SR 96 Widening and Reconstruction

Value Engineering Study Report

Preliminary Design Stage

re: STP-155-1(21) CSNHS-0008-00(406)(407)
P.I. Nos. 322450, 0008046, 0008407
SR 96 Widening and Reconstruction Project
Houston and Peach Counties, Georgia
Value Engineering Study Report

ALTERNATIVE NO.:
TS-1A

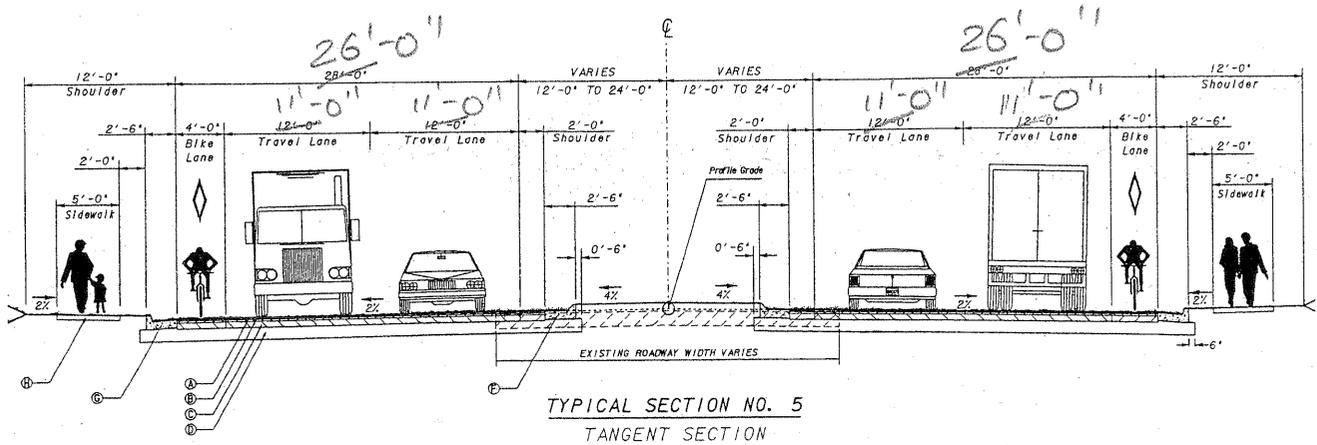
| ALT. NO. | DESCRIPTION | ORIGINAL COST | ALTERNATIVE COST | INITIAL COST SAVINGS | RECURRING COST SAVINGS | TOTAL PW LCC SAVINGS |
|-----------------------------|---|---------------|------------------|----------------------|------------------------|----------------------|
| TS-1A | Construct 11-ft. travel lanes | \$ 2,677,013 | \$ - | \$ 2,677,013 | | \$ 2,677,013 |

ALTERNATIVE NO.:
TS-13

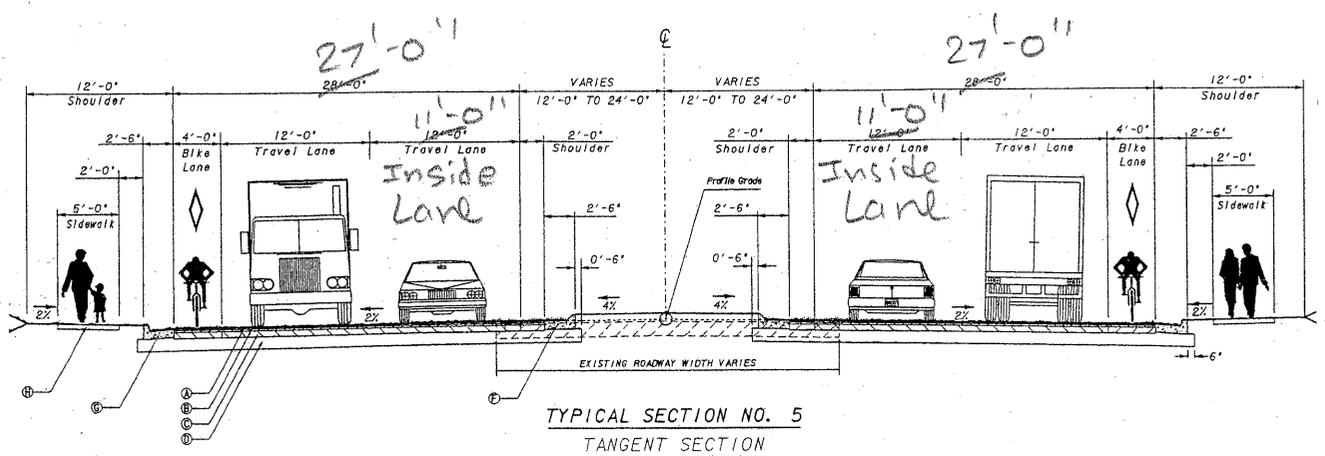
| ALT. NO. | DESCRIPTION | ORIGINAL COST | ALTERNATIVE COST | INITIAL COST SAVINGS | RECURRING COST SAVINGS | TOTAL PW LCC SAVINGS |
|-----------------------------|---|---------------|------------------|----------------------|------------------------|----------------------|
| TS-1B | Construct 11-ft. inside travel lanes | \$ 1,367,078 | \$ - | \$ 1,367,078 | | \$ 1,367,078 |

ALTERNATIVE NO.: **TS-3**
 SHEET NO.: **2 of 5**

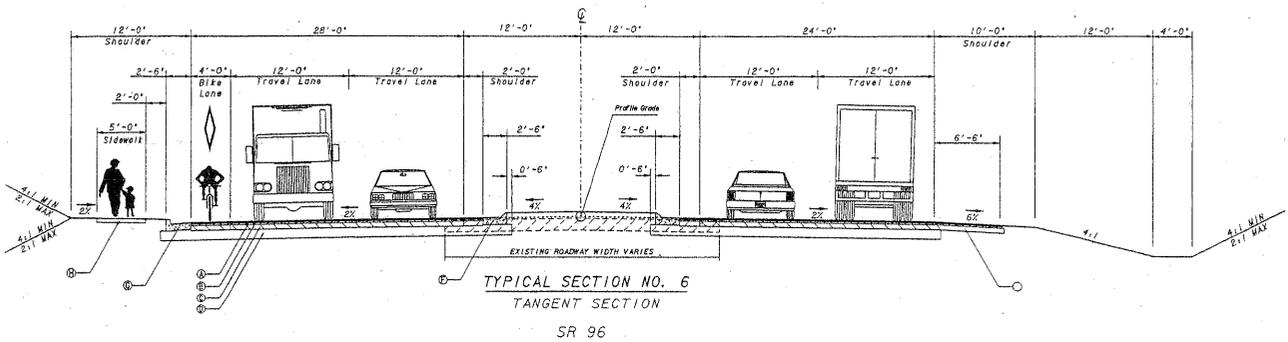
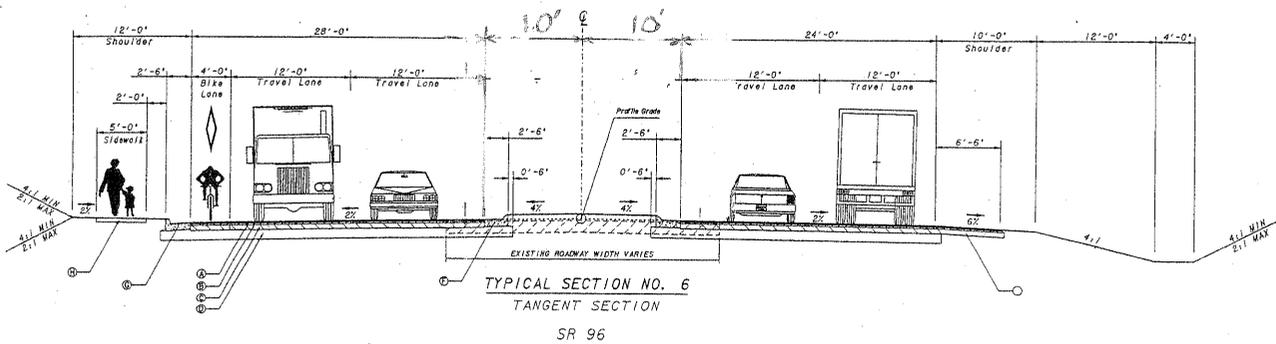
Eliminate the 2-ft. inside shoulders for a revised 20-ft. median.

ALTERNATIVE NO.: **TS-4**

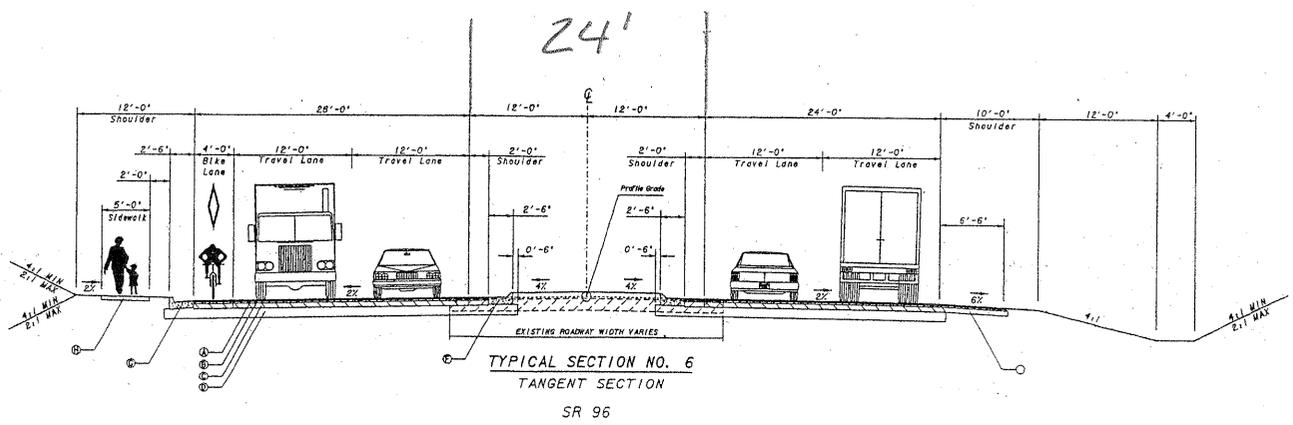
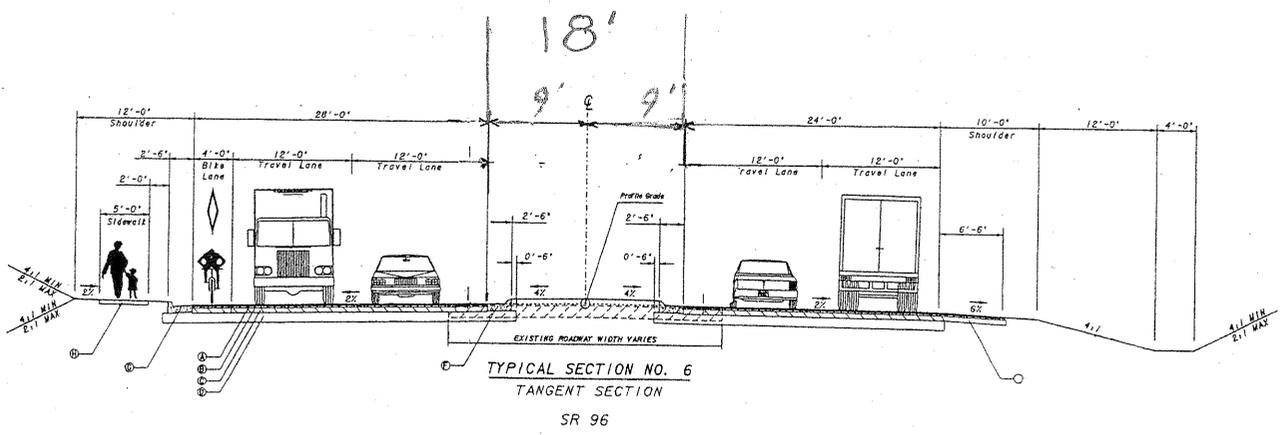
Eliminate the 2-ft. inside shoulders and reduce the distance between the curbs by two feet for a revised 18-ft. median.

ALTERNATIVE NO.: **TS-5**
 SHEET NO.: **2 of 5**

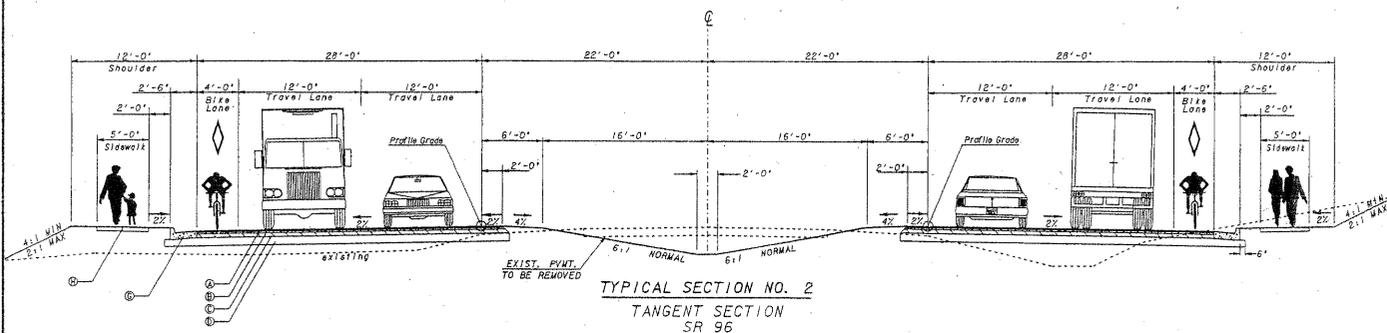
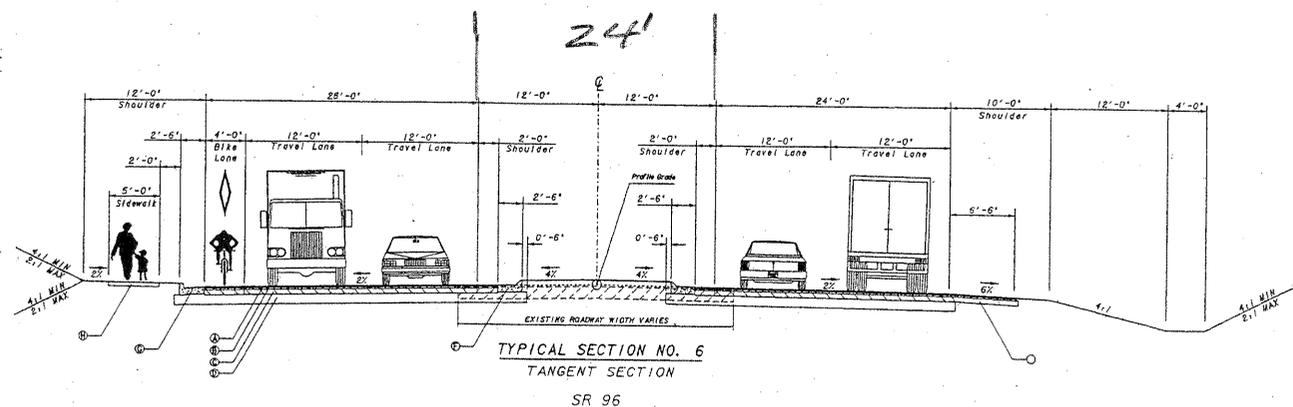
Conform at the west end of Phase 1 to the existing 44-ft. median, tapering out to a 24-ft. raised median beginning at Station 1079+00, the Johnson Road intersection. Revise the all of the project's remaining 44-ft. depressed median to a 24-ft. raised median.

The current design would allow the expansion from 4 lanes to 6 lanes into the median for approximately 3 out of the 9 miles. The addition of lanes for this corridor into the 44-ft. depressed median would be discontinuous. It may behoove GDOT, in a cost saving mode now, to save the investment of planning for the future lane addition that may never be built. Constructing a 24-ft. raised median is a reasonable, logical way to carry out this project.

ALTERNATIVE NO.: **TS-6A**

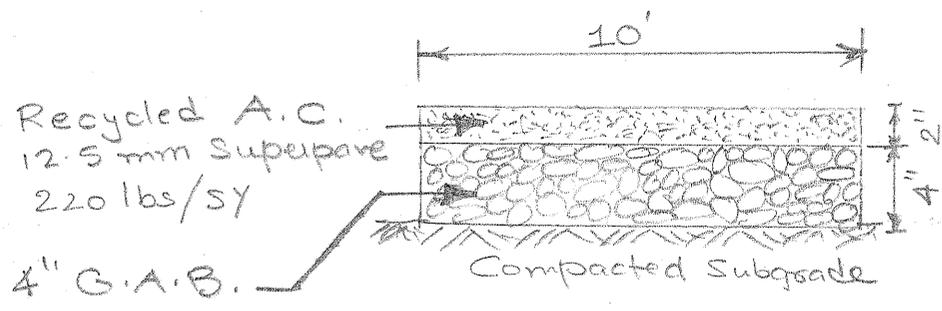
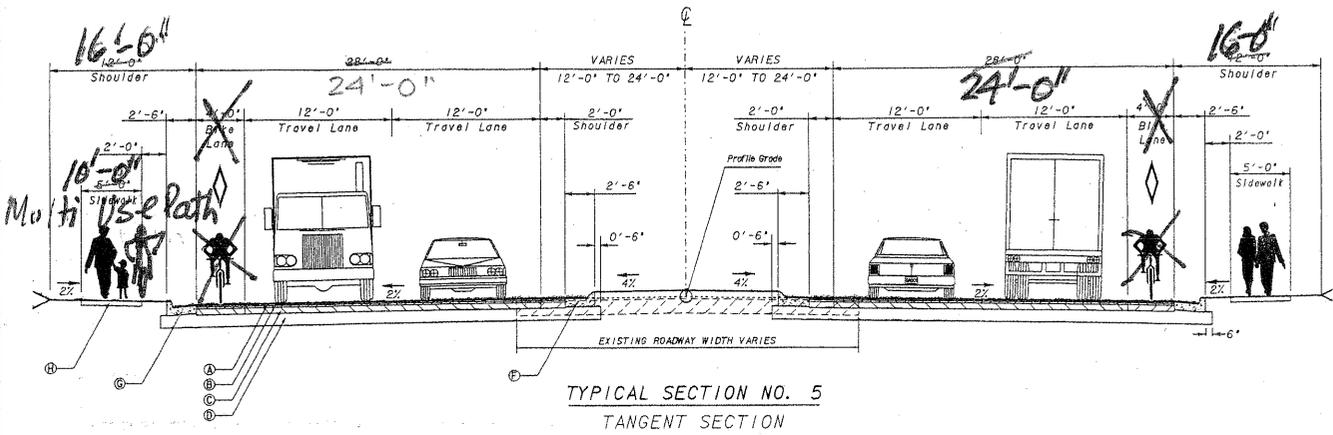
Eliminate the bike lanes from both sides of the road. Keep a 5-ft. sidewalk on one side of the road and replace the opposite sidewalk with a single 10-ft.-wide multi-use path. The multi-use path pavement section would consist of 2-in. asphalt concrete over 4-in. G.A.B. on a compacted subgrade.

ALTERNATIVE NO.:
 TS-6B

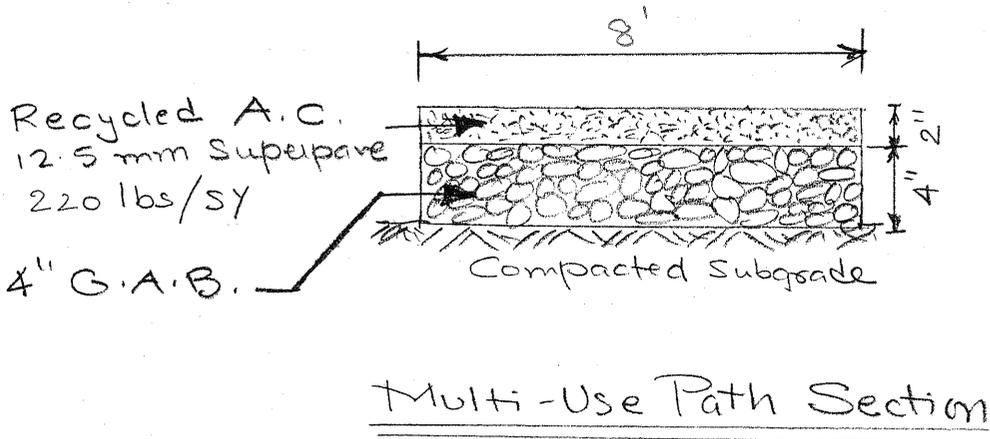
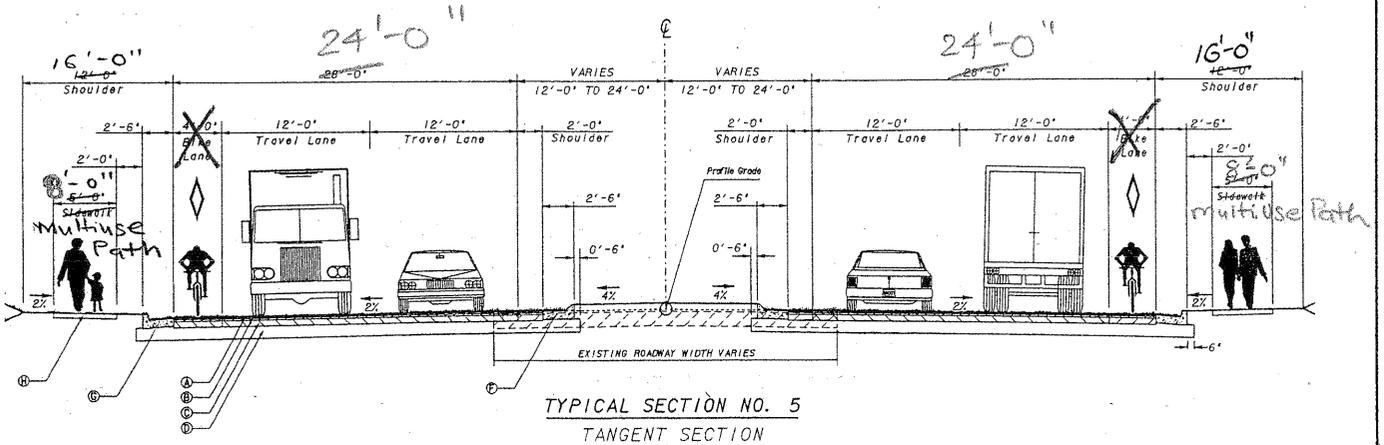
Eliminate the bike lanes and the 5-ft.-wide concrete sidewalks on both sides of the road and replace with two 8-ft.-wide multi-use paths/per direction. The multi-use path pavement section would consist of 2-in. asphalt concrete over 4-in. G.A.B. on a compacted subgrade.

TS-8

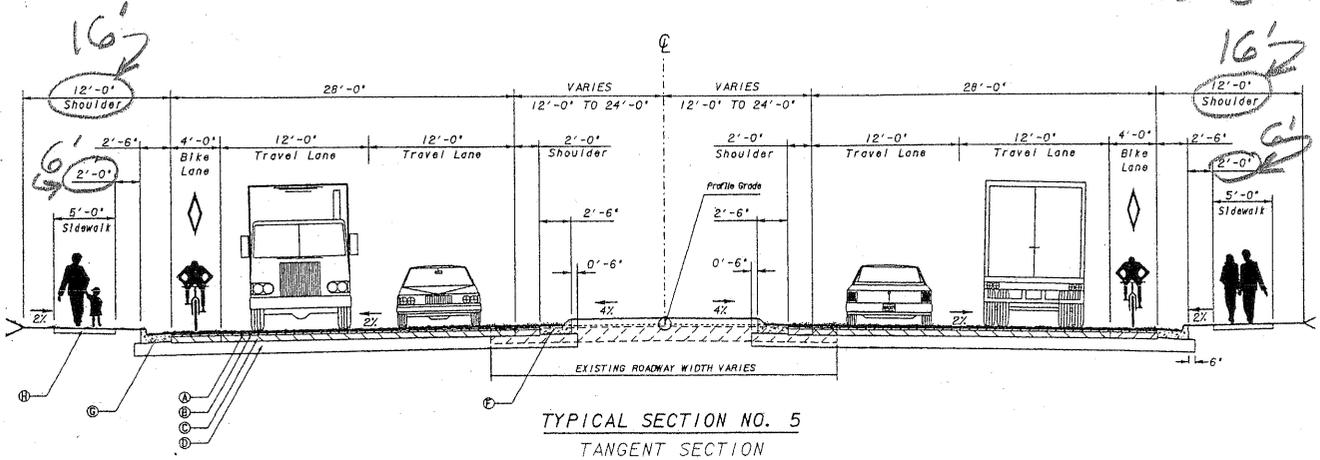
Current design proposes to build 12-ft. urban shoulders, even though the planned right-of-way acquisition currently accommodates 16-ft. urban shoulders.

A-1
SHEET NO.: 4 of 5

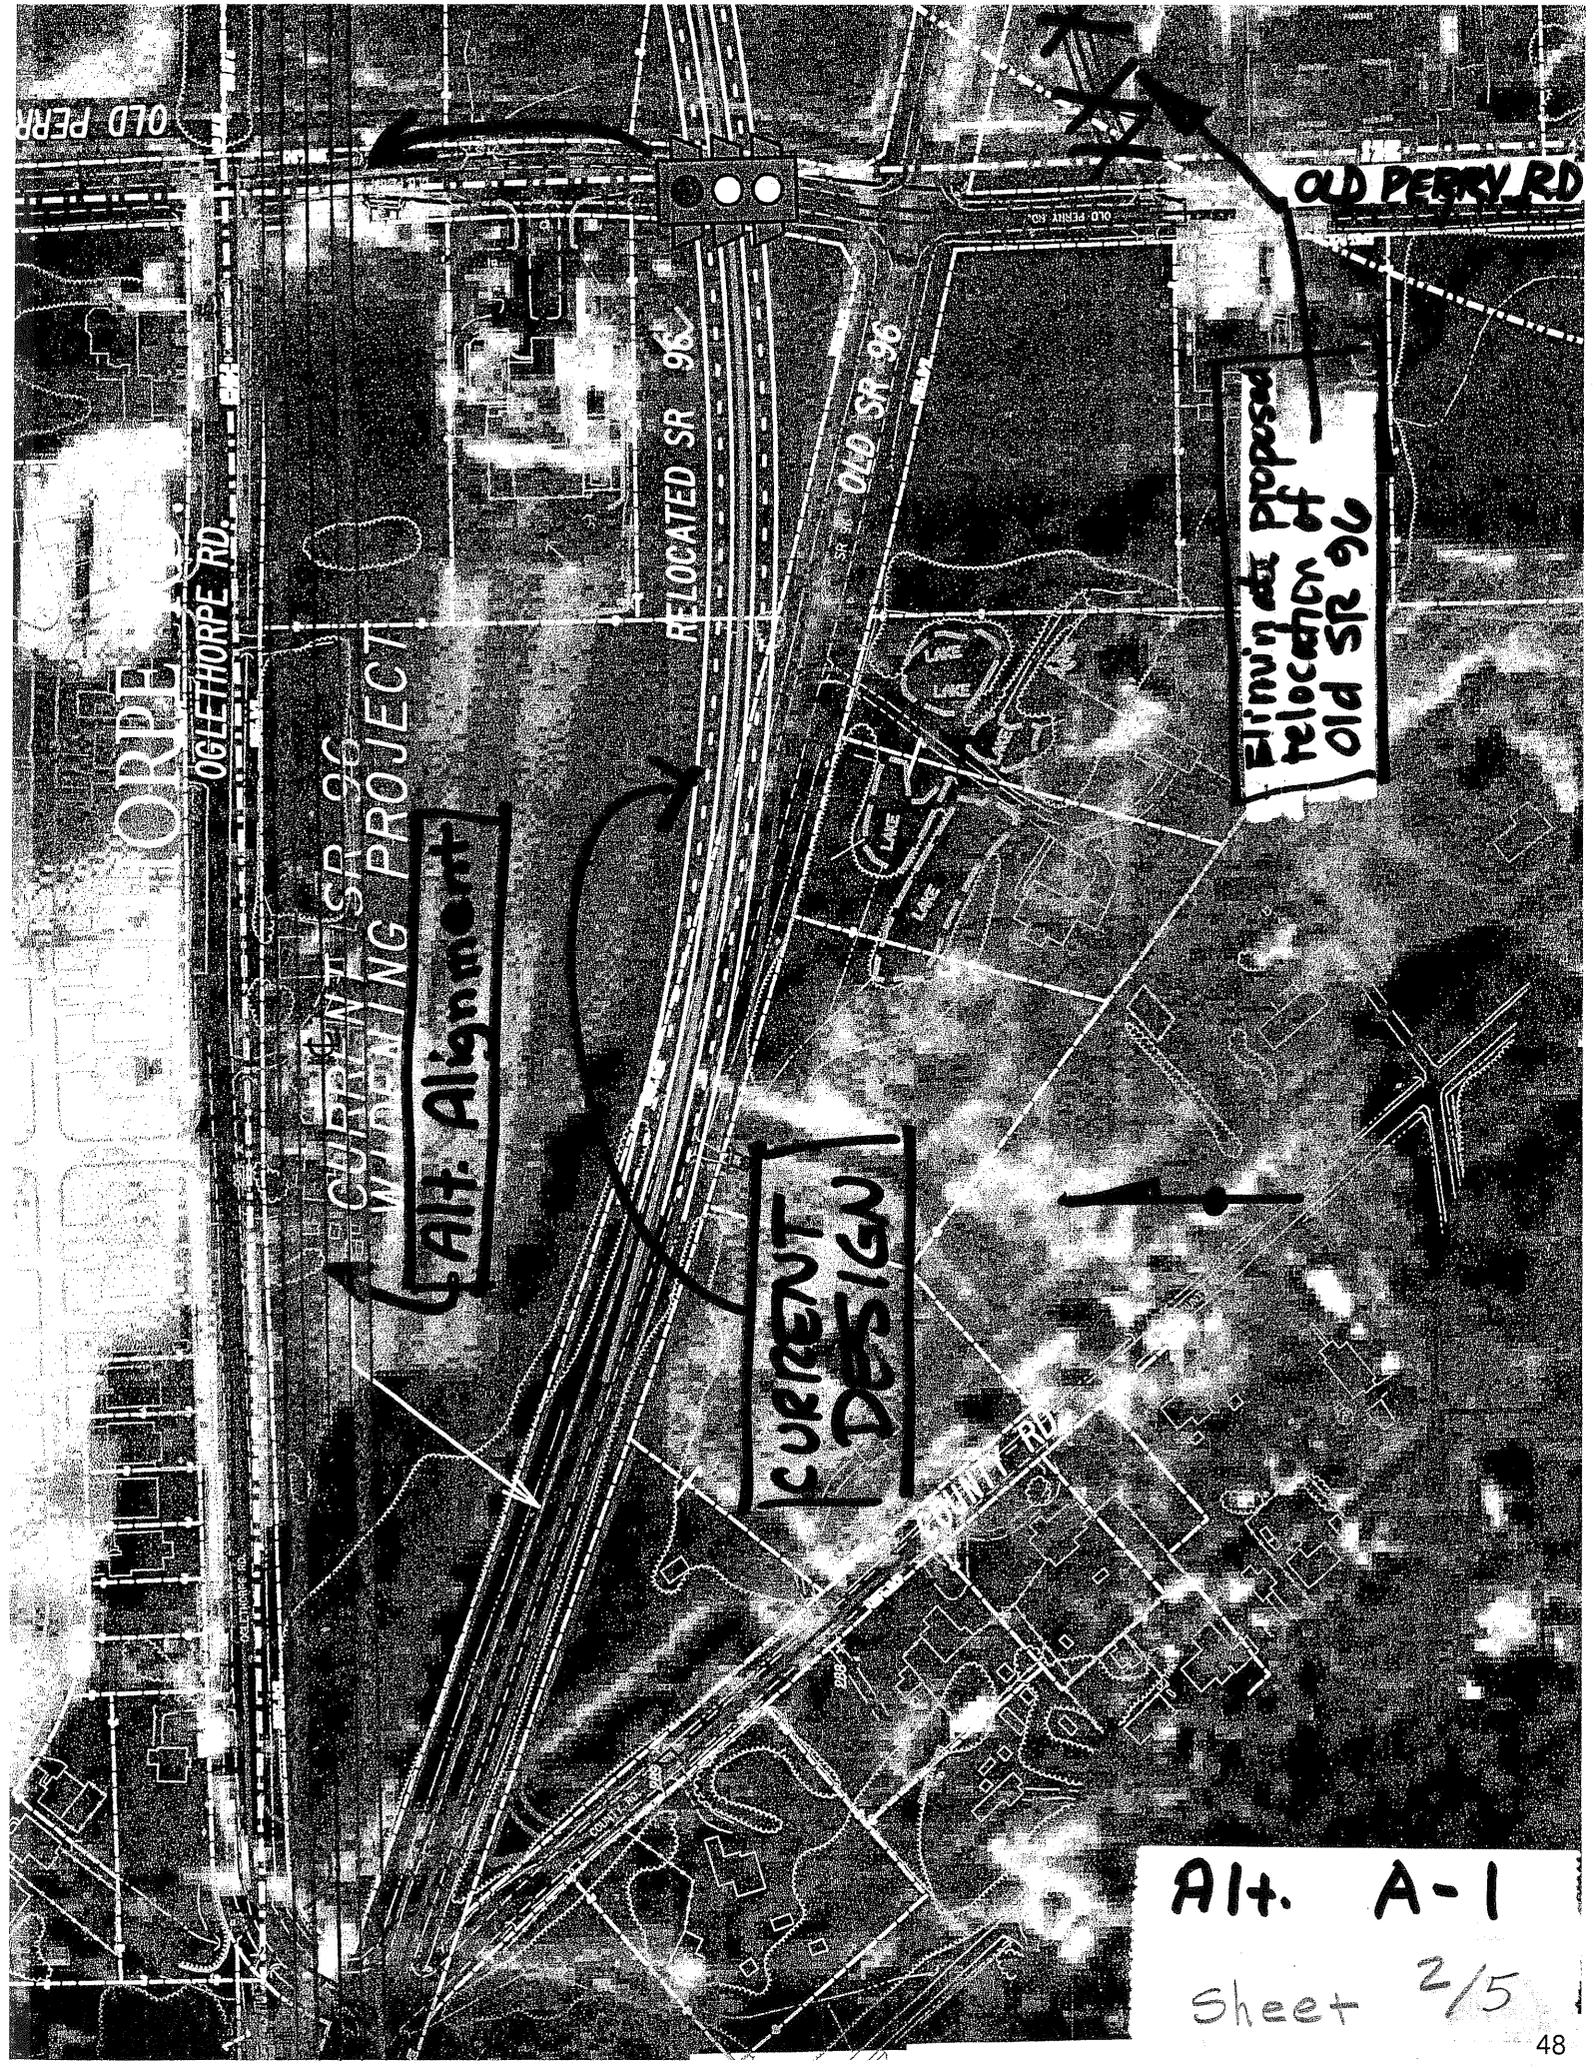
Revise the SR 96 alignment in this vicinity to follow along Oglethorpe Road. Use the existing Oglethorpe Road right-of-way to relocate SR 96. The new alignment would allow approximately 700-ft. between the relocated SR 96/Old Perry Road and the Old SR 96/Old Perry Road intersections. The relocation of Old SR 96 just east of Old Perry Road would be eliminated.
